COUNCIL ASSESSMENT REPORT

HUNTER AND CENTRAL COAST REGIONAL PLANNING PANEL

PANEL REFERENCE & DA NUMBER	PPSHCC-192 Section 8.2(1) Review of DA2018/01351 (CN application Ref RE2023/00003)
PROPOSAL	Sec 8.2(1) Review of DA2018/01351 - Subdivision of 6 lots into 858 residential lots, 7 development lots for future residential development; 14 Local Centre Lots; 1 Neighbourhood Centre Lot; 3 Residue Lots; and 21 lots for road widening, public reserves and drainage reserves plus associated works.
ADDRESS	Lot 100 DP1252590 Lot 5 DP 1230960 Lot 48 DP115128 Part Lot 1 DP1156243 Lot 4 DP1253716 Part Lot 3 DP 1230960 (Lot 2 & 3 in DP1230960 associated with condition of DA2015/10393) 144 & 177 Woodford Street Minmi NSW & 610 Minmi Road Minmi NSW
APPLICANT	Winten (No. 21) Pty Ltd
OWNER	Winten (No. 21) Pty Ltd
DA LODGEMENT DATE	 DA lodgment date - 3 December 2018 Application for review lodgment date - 6 April 2023
APPLICATION TYPE	Local Development
REGIONALLY SIGNIFICANT CRITERIA	Original application subject to Clause 2 of Schedule 7 of State Environmental Planning Policy (State and Regional Development) 2011 which declares the proposal regionally significant development as the development has a

FIGURE 9 - Possible Land Zoning Discrepancies - South-West Area (Source - SEE Figure 10)

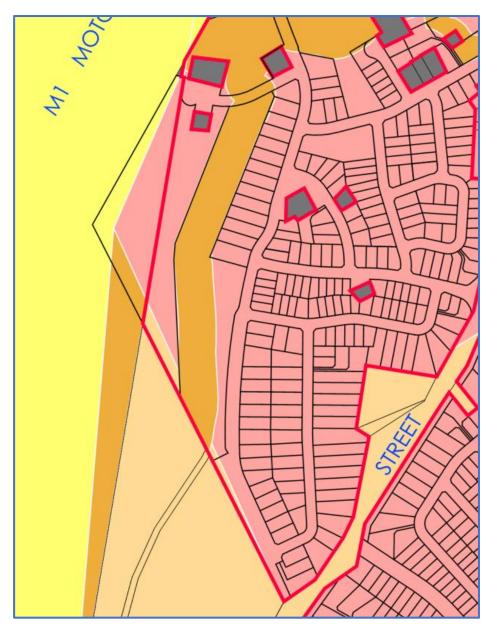
In the southwest corner of the development site, a number of seemingly unintentional discrepancies exist between the cadastral boundaries and land zone boundaries gazetted under both the NLEP2012 and the Lake Macquarie Local Environmental Plan 2014 (LMLEP2014). These discrepancies are evident in **Figure 9** below.

Investigations undertaken by CN suggest the discrepancy may have resulted from the LEP maps being prepared based on the Digital Cadastral Database relied on by the DPE 'Spatial Viewer' and not based on actual boundaries derived from deposited plans.

Figure 25 – Water crossing locations and 1%AEP (20% blockage) flood depths and levels (Source MA Supplementary flood advice - 12 March 2024, Figure 1)

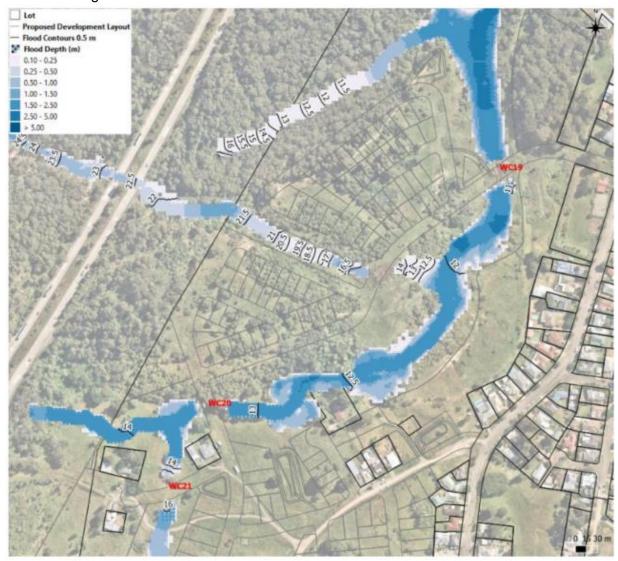
The six key flood issues are outlined below, with relevant discussion. These relate to the area depicted below in **Figure 25** and involve impacts upon existing Lot 38 and TfNSW land west of the site, along with risk associated with three water crossings (WC19, WC20 & WC21), providing access to stages 37 and 39.

In its response dated 13 September 2023, MA acknowledges that overtopping of roads at waterway crossings WC19, WC20 and WC21 (refer ADW Johnson drawings 126, 121, and 117) will occur in the Probable Maximum Flood (PMF).

In its response dated 12 March 2024, MA provides the requested information detailing the estimated frequency of overtopping of roads at waterway crossings WC19, WC20 and WC21 (refer ADW Johnson drawings 126, 121, and 117). The estimated frequency of overtopping is 1 in 1,1000 years, 1 in 5,600 years and 1 in 10,200 years for crossings WC19, WC20 and WC21, respectively.

Figure 27 - Previously proposed boundaries of Workshop Park (outlined in red). The park boundaries bisected the workshop and boilers.

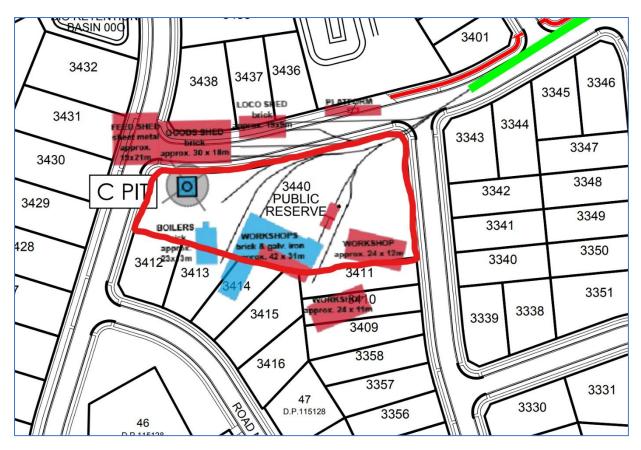
Although no archaeological assessment has been provided, additional research and analysis has been undertaken regarding the likely original layout of the former workshop precinct. The report by GBA Heritage proposes an amended lot layout for Workshop Park which includes the whole of the former brick workshop building, boilers and C Pit. The amended layout achieves a more orderly configuration compared to the previously proposed park layout, which bisected the former workshop building and boilers.

Subject to conditions, the amended park layout, being the result of additional research conducted by GBA Heritage, is considered to be a reasonable outcome. The park will provide the opportunity for an expansive heritage interpretation programme. **Figures 27** and **28** below show a comparison between the previous and current proposed Workshop Park extents overlaid on the locations determined for the former workshop buildings and structures.

Figure 29 - Extract from Infrastructure Staging Plan

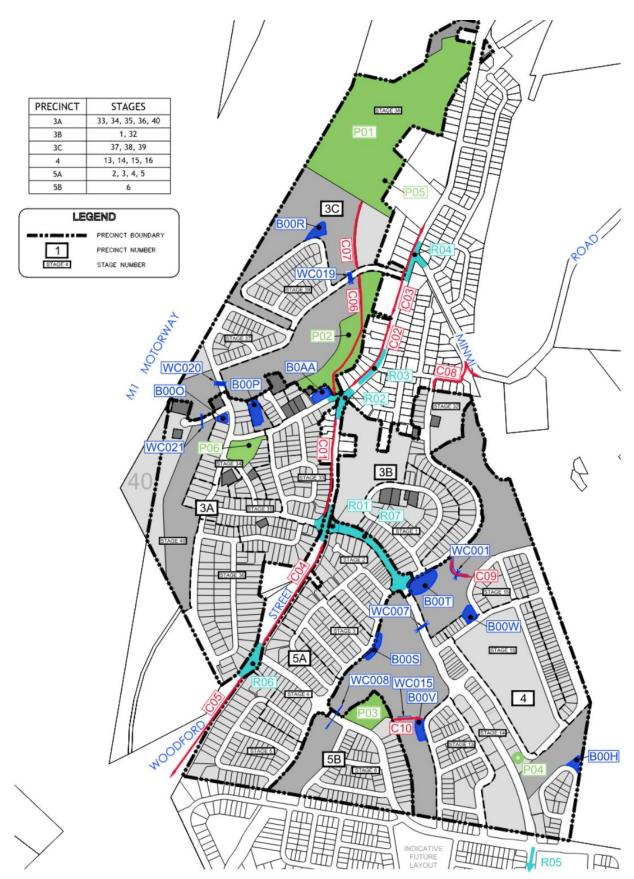
The ISPR is considered to be satisfactory with the exception that:
